**CLIENT NAME** Fort Wayne Community Schools  
**Project Name & Number:** Wayne HS Dining - 20230232  
**Date:** 10/24/2024

## **ADDENDUM NO. 2**

**A9.1F**

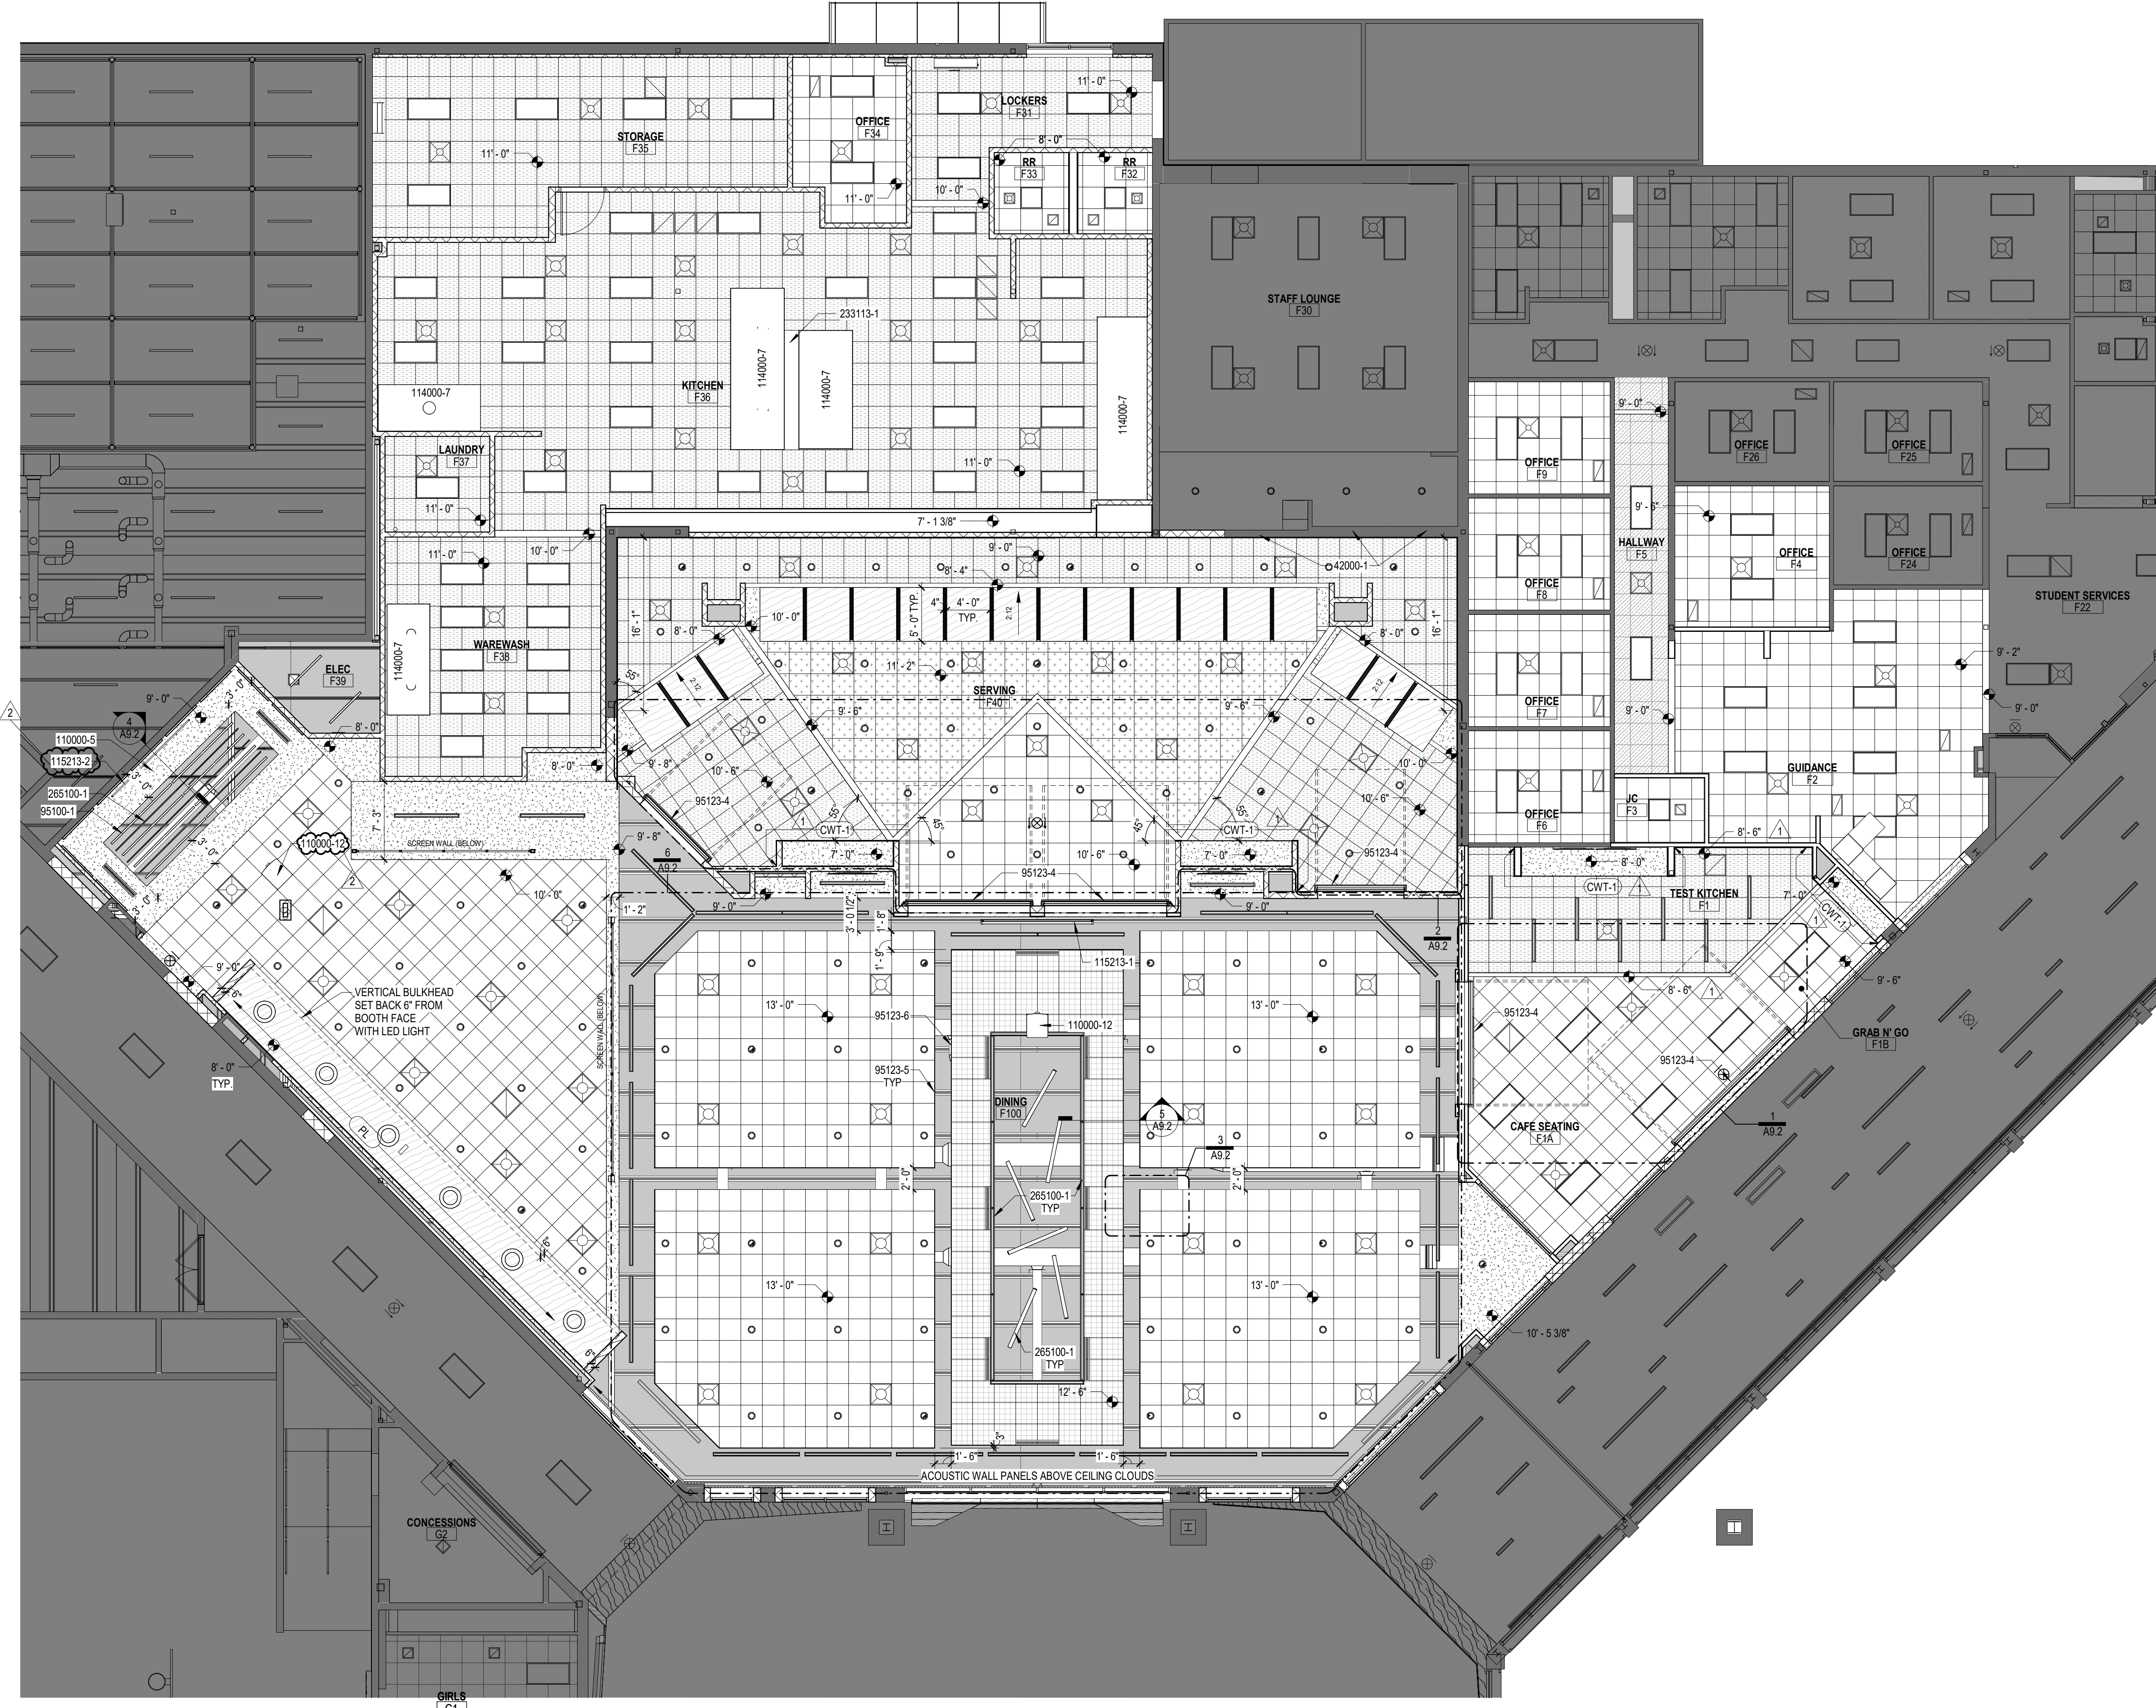
Location: Drawings, Sheet A9.1F - Reflected Ceiling Plan - Main Level - Unit F, Sheet E2.1F - Power Plan - Main Level - Unit F, E6.2 - Panel Schedules  
Description: Projector and motorized screen added to Northwest corner of Dining F100, see plan. See panel schedule for circuitry.

**1 FINISH FLOOR PLAN - MAIN LEVEL - UNIT F**  
SCALE: 1/8" = 1'-0"

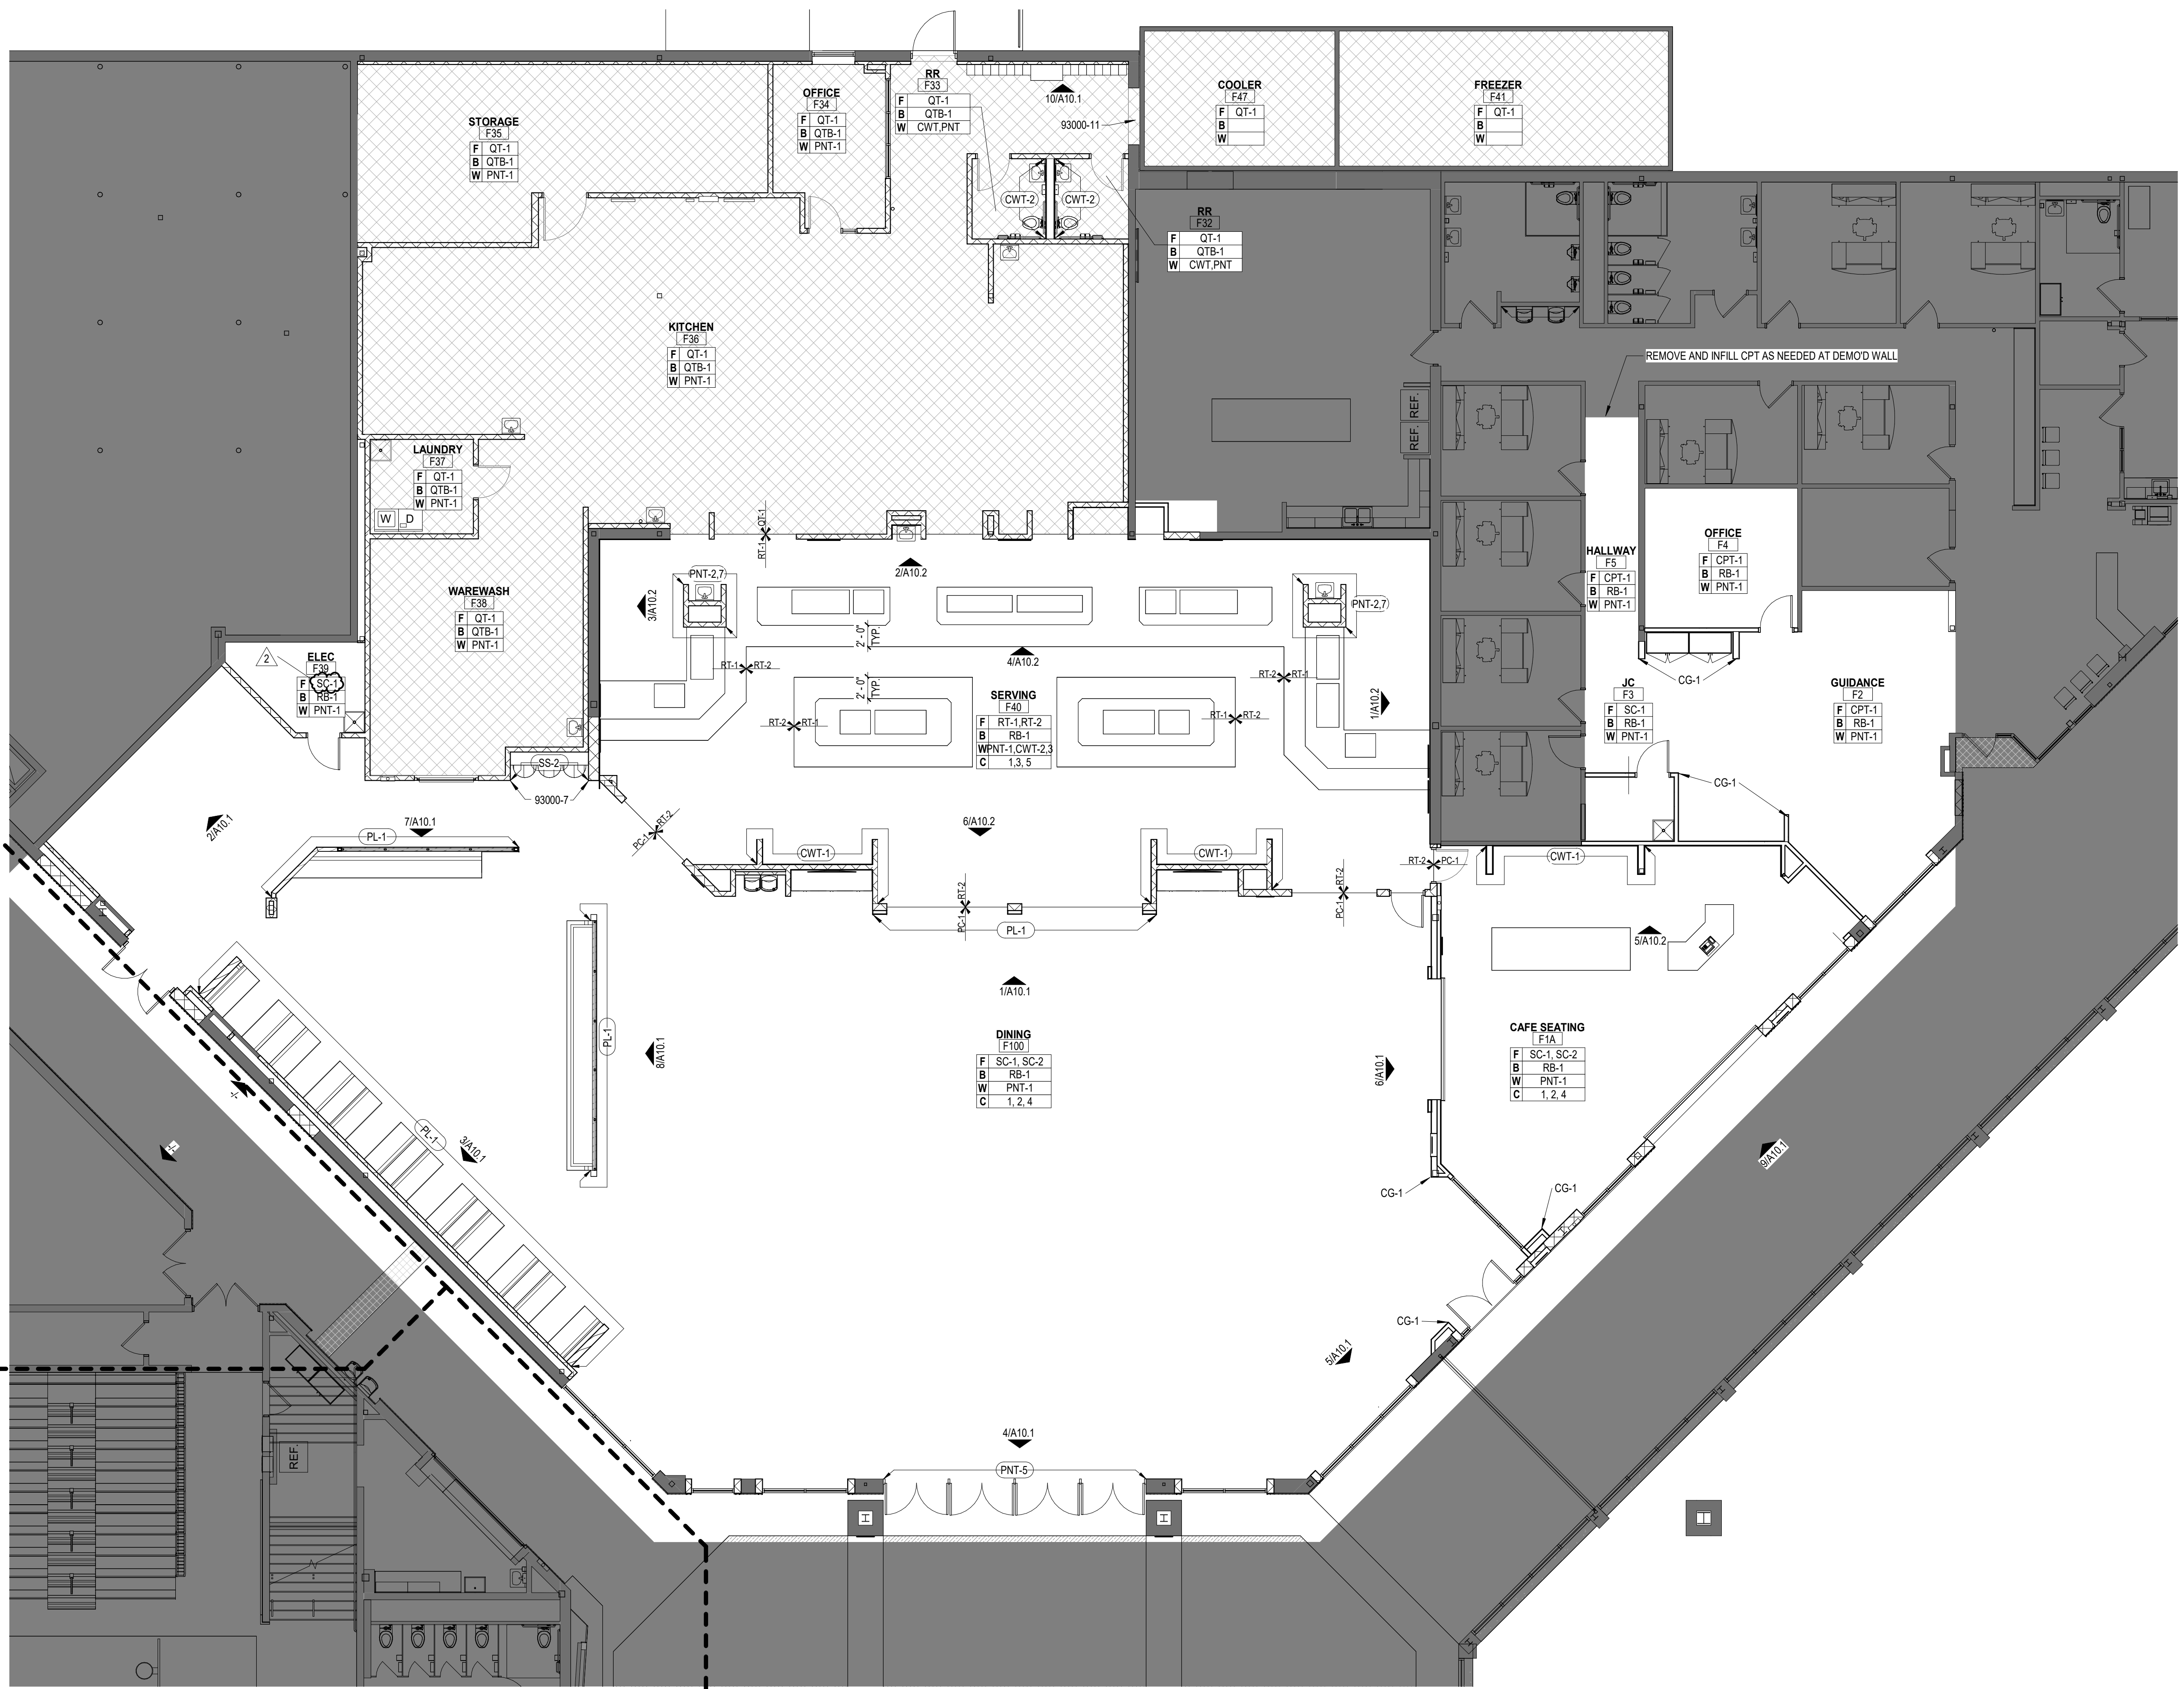
Location: Drawings, Sheet A11.1F - Floor Finish Plan - Main Level - Unit F  
Description: Elec F39 flooring to be SC-1.

**1 ELECTRICAL DEMOLITION PLAN - MAIN LEVEL - UNIT F**  
 SCALE: 1/8" = 1'-0"  
 NORTH

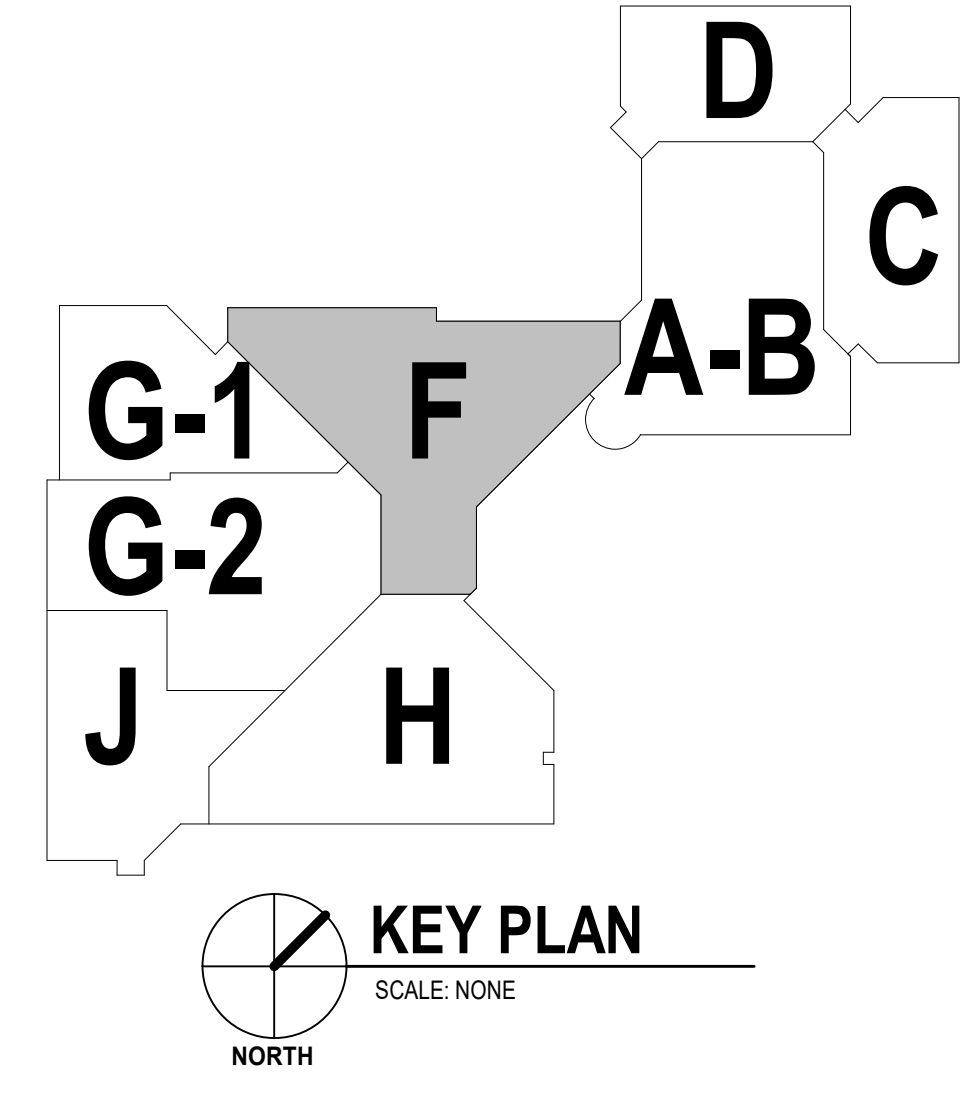
Location: Drawings, Sheet E1.1F - Electrical Demolition Plan - Main Level - Unit F  
Description: Power to temporary retherm ovens specified for cafeteria use during construction.
